**MOBILE FACILITY PROGRAM REVIEW  
ACTION ITEM**

ACTION ITEM NO.: 2-204

SECTION B-B SH 2  
ROTATED 180°

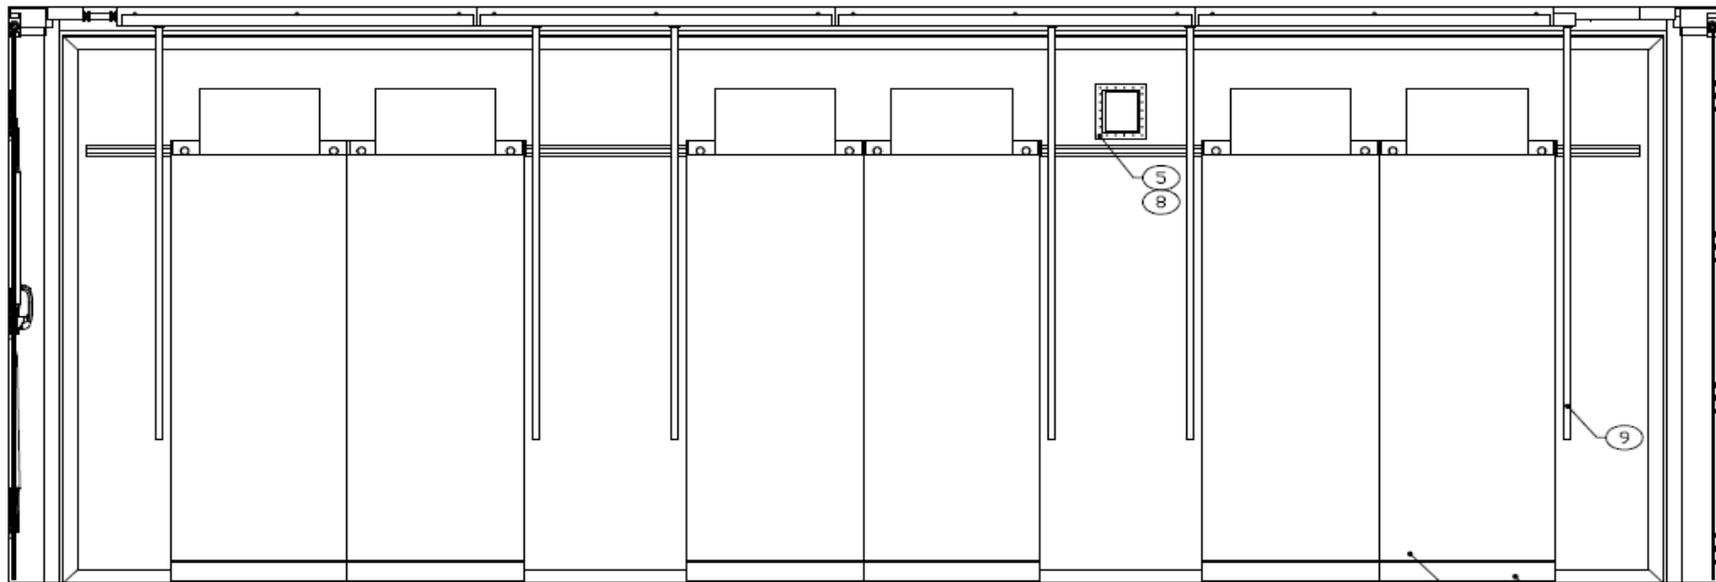
**PROBLEM:** The Aviation Logistics Information Management and Support (ALIMS) Department TBA allowances for Mobile Facilities (MF) do not support the requirements placed on ALIMS to support and repair Aviation Logistics Information Technology (AVLOGIT) requirements. Specifically there is no MF configuration to support emerging systems and servers that ALIMS is required to maintain. This has caused the ALIMS to de-configure existing MF's to support placing servers for the existing MV-22 CAMEO, IMDS/HUMS servers.

**RECOMMENDATION:** Request adding two MF configurations similar to DP-18A to AIS NSD. One configuration will be for fixed wing MALS, and the other for rotor wing MALS. This will allow program offices that push servers to specify there facility requirements to either an SV-01, or SV-02 (conceptual MF codes).  
This MF will require a minimum of the following characteristics:  
Two Environmental Control Units.  
Railing on the walls to support securing large rack mount servers, to prevent possible tipping over of top heavy systems.  
A mix of 125v 15amp and 20amp quad port receptacles, each on its own circuit.  
Conduit wired with 30amp cable to support direct wiring to circuit breakers if needed.  
Ceiling data path / metal raceway or Panduit.  
Removable ECU rails.  
Three stools to support placed systems.  
Low profile, (thin) ceiling lights.
